# UNITED STATES PATENT AND TRADEMARK OFFICE

10/565,892

# Office Action Summary

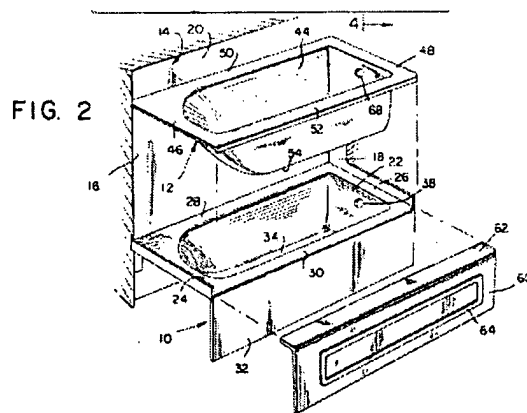
14. The phrase “wherein a ratio of thickness of the acrylonitrile butadiene styrene material to the acrylic cap is 9:1” in claim 47, lines 2-3 is vague and indefinite since it is unclear whether the “cap” is referring to something that someone wears, a polymer, a wall or something else and is where is the “thickness”.

15. Claim 47 recites the limitation “the acrylic cap” in lines 2-3. There is **insufficient antecedent basis** for this limitation in the claim.

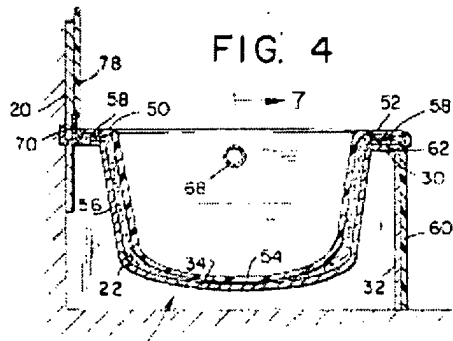
Regarding claims 41 and 52-56, Altman ('071) teaches a composite article having an upper member of plastics material having an undersurface (See col. 4, ll. 3-7 and FIG-2, #12 with an undersurface.) and

a lower member of plastics material that together form an outer shell (See FIG-2, #60, #10 and col. 7, ll. 3-5.), and an inner core of filler within the shell (See FIGs 4 and 7, #56.), the upper member being spaced from the lower member to define a gap therebetween,

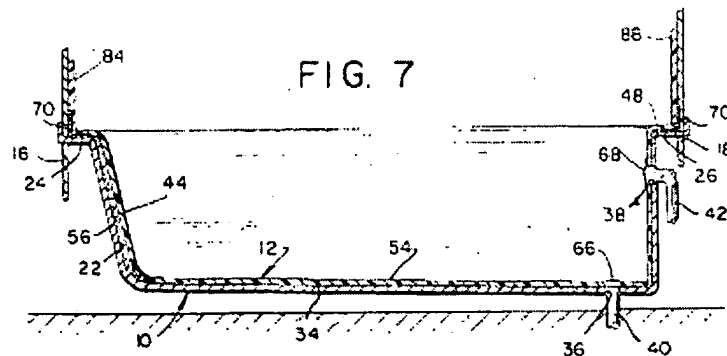
the gap being constructed and arranged to separate the upper member from the lower member, to receive the core, and to provide strength and rigidity to the article and wherein the core extends between the upper member and the lower member to support substantially the entire undersurface of the upper member (See FIGs 4 and 7 and col. 6, ll. 11-17 wherein the upper/lower members are spaced with core #56 between and wherein the core substantially supports the undersurface. Furthermore, Applicant has not disclosed what substantially means.).
